**ADDENDUM # 1**

<b>Project</b>	TA Blakelock High School Renovations	<b>Project No.</b>	2215-C
<b>Location</b>	1160 Rebecca Street, Oakville, ON	<b>Date of Issue</b>	2025 04 24
<b>Owner</b>	Halton District School Board	<b>File</b>	2215/7.1.3

This Addendum forms part of the Contract Documents and amends the original Drawings and Specifications, dated 2025 04 17, and all preceding Addenda, as noted below.

**A1-5 DRAWING A106 SECTION DETAILS**

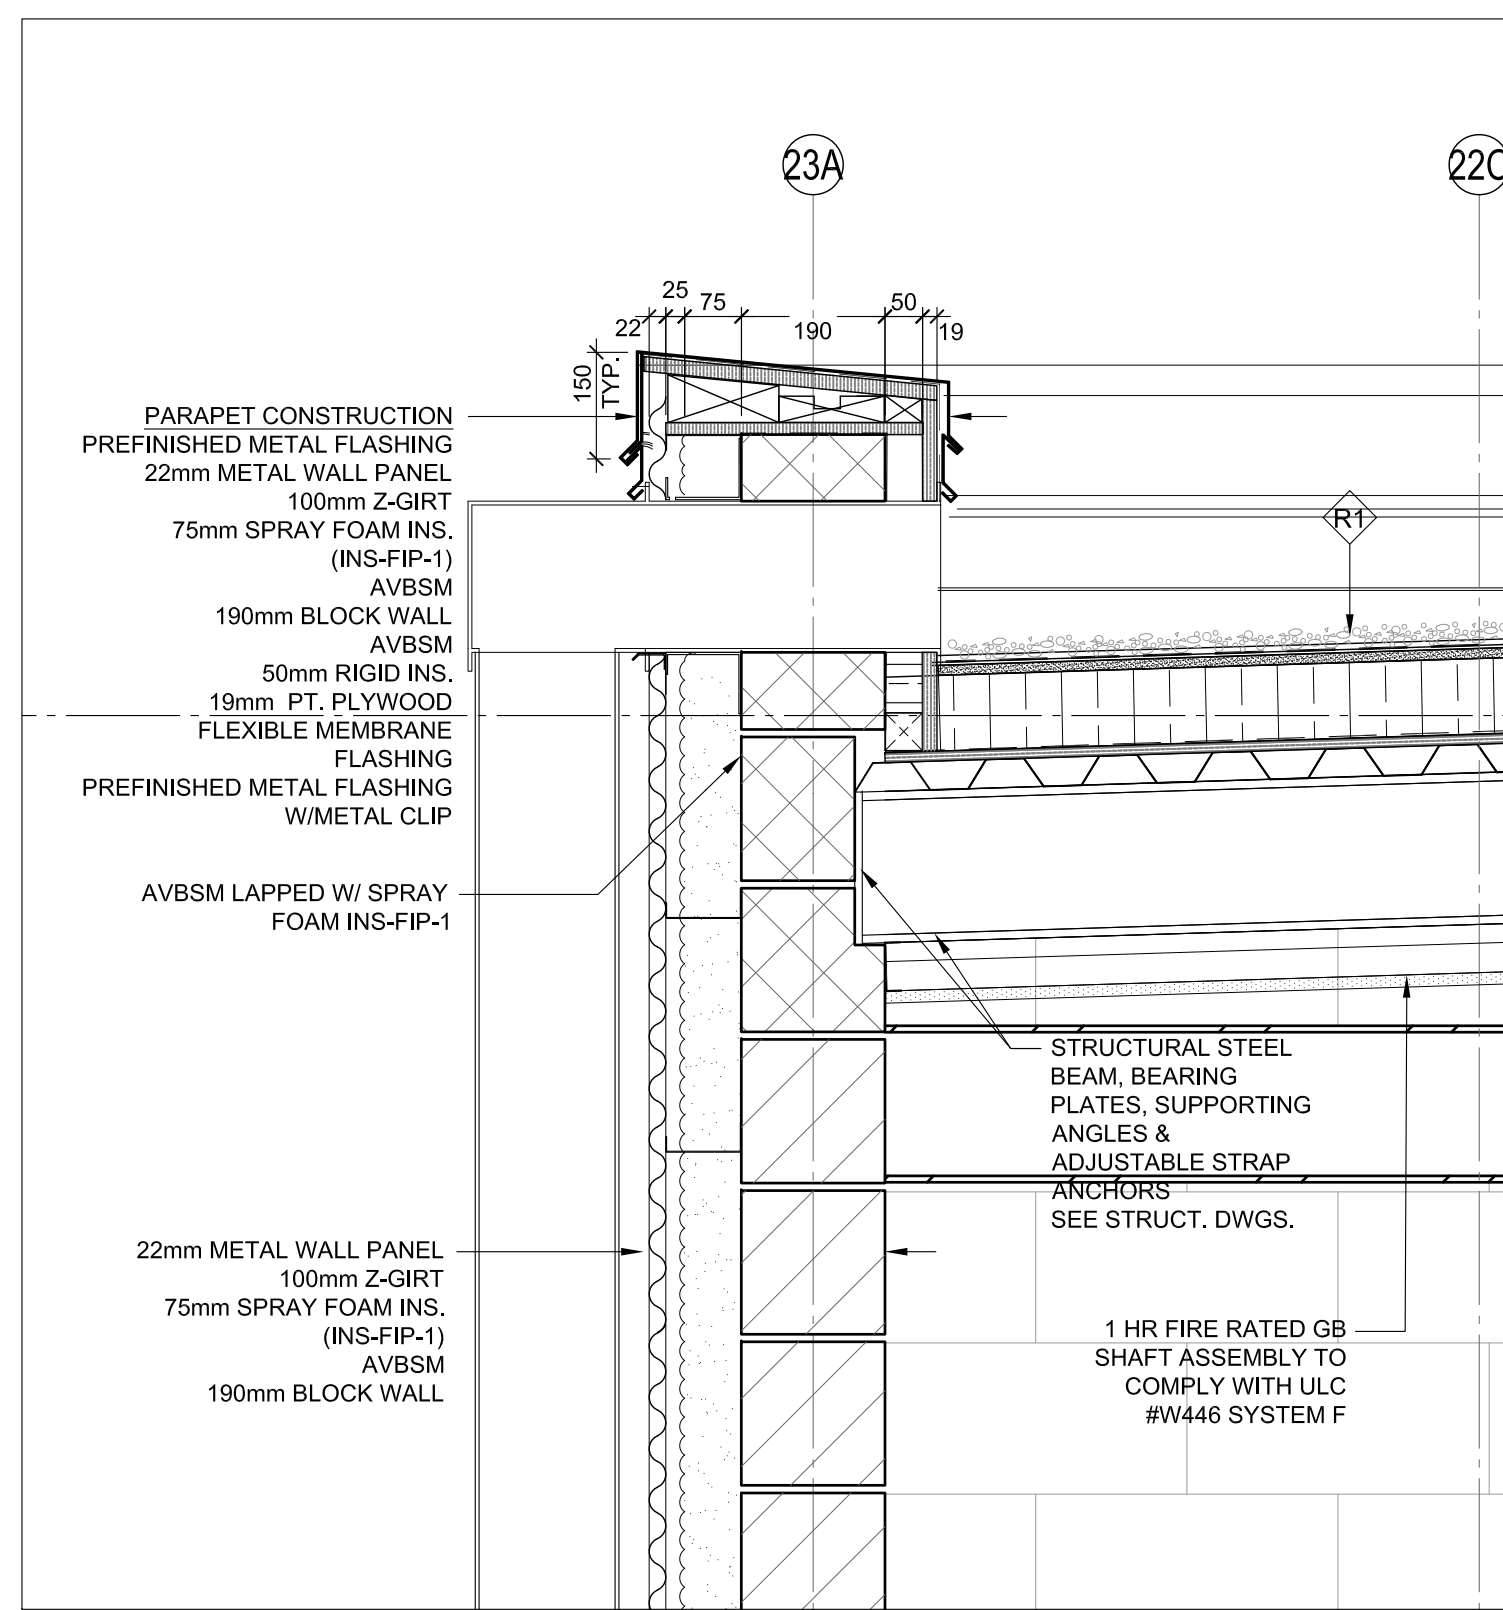
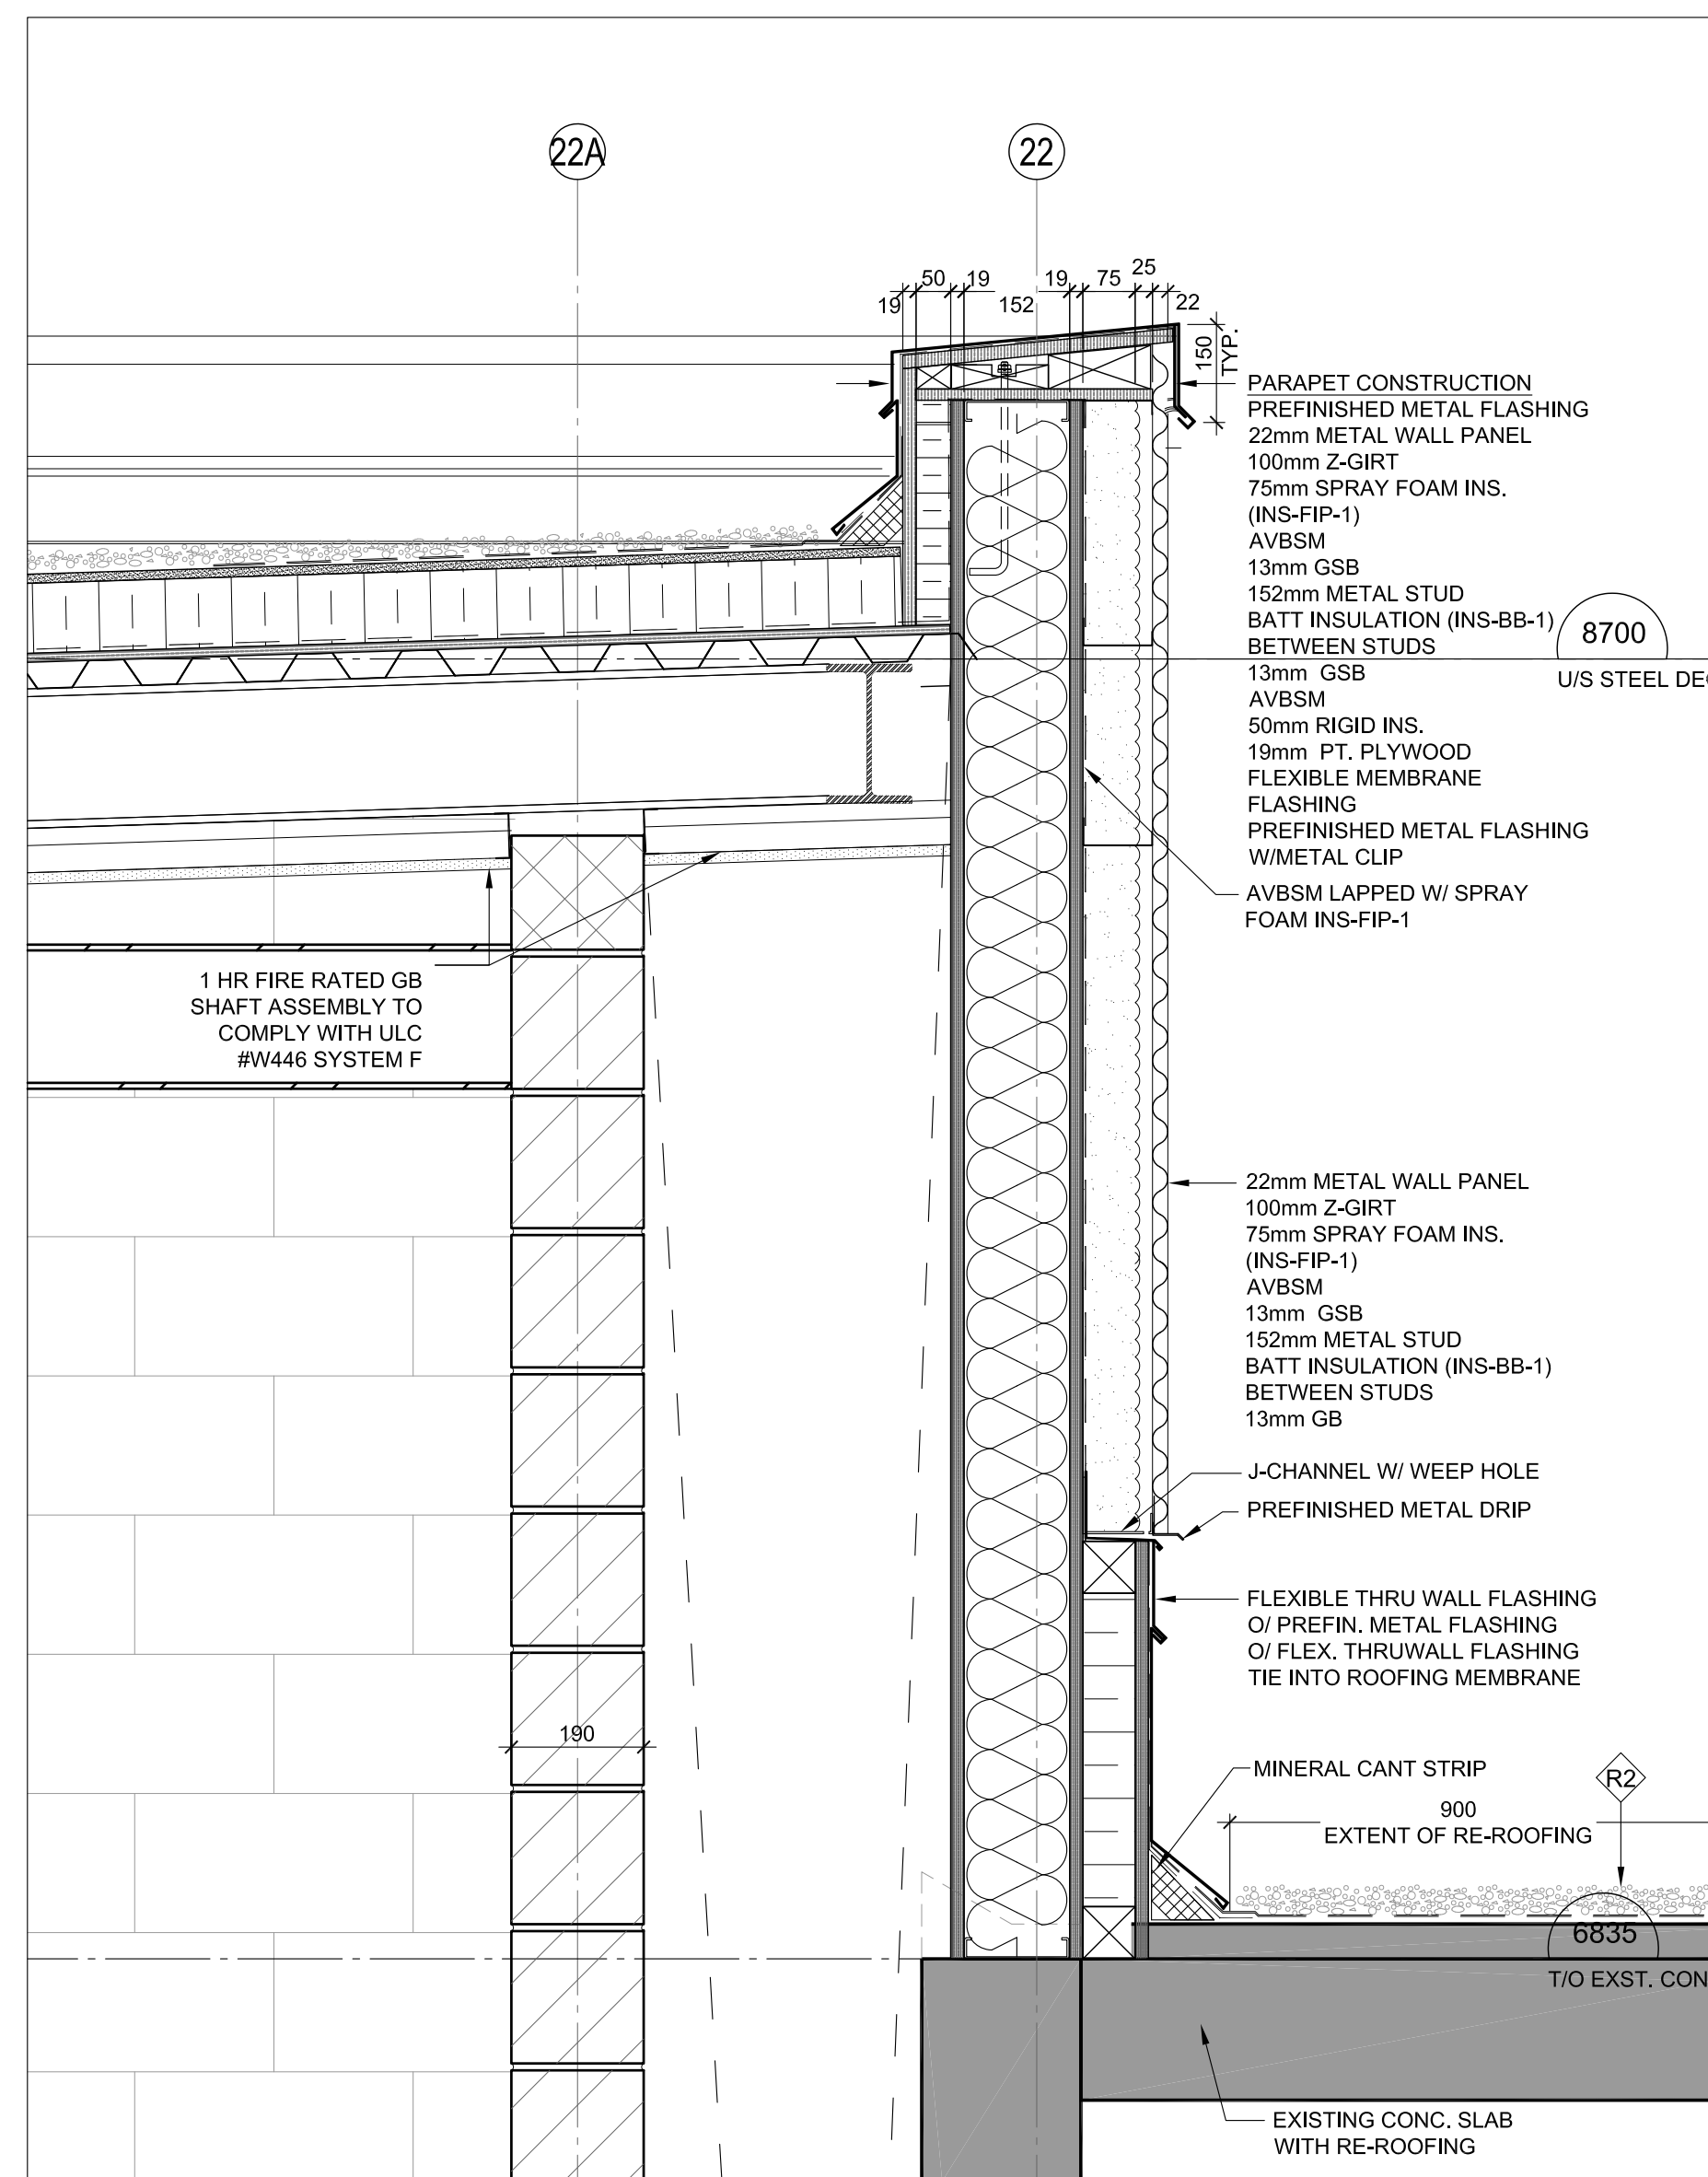
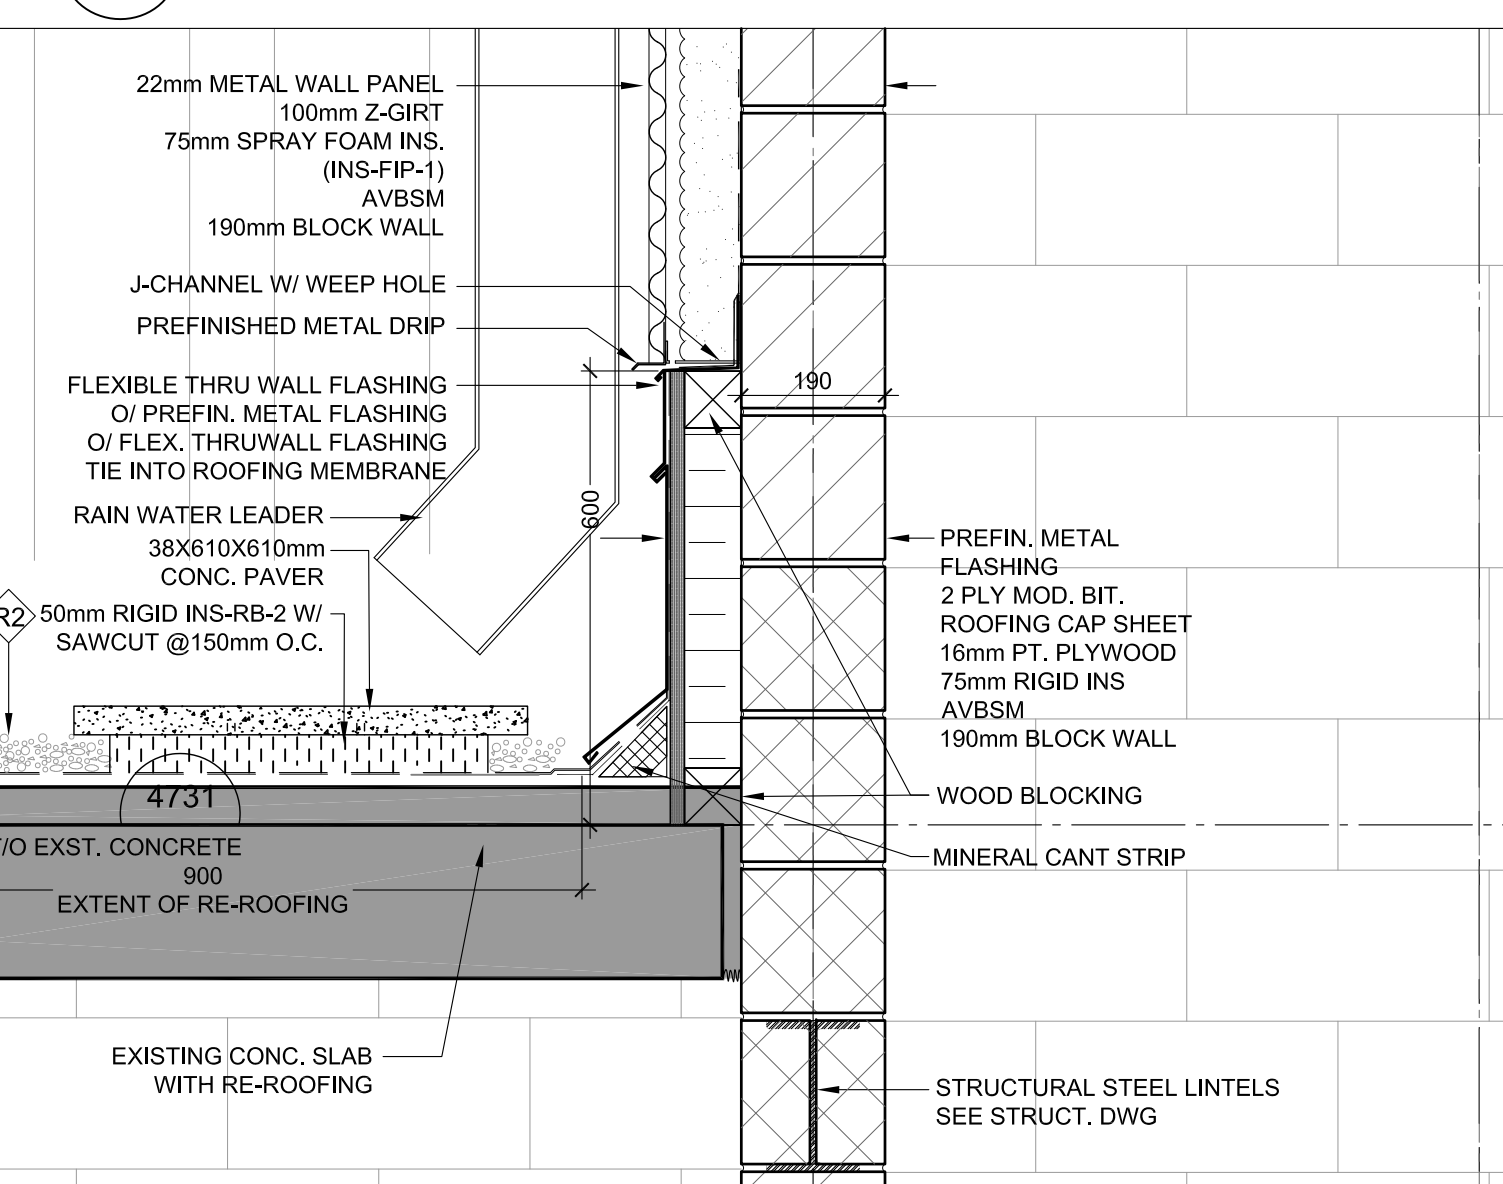
- .1 Replace Drawing with the attached Revision No. 2.
- .2 Drawing reissued to revise fire protection notes and added details 14-18.
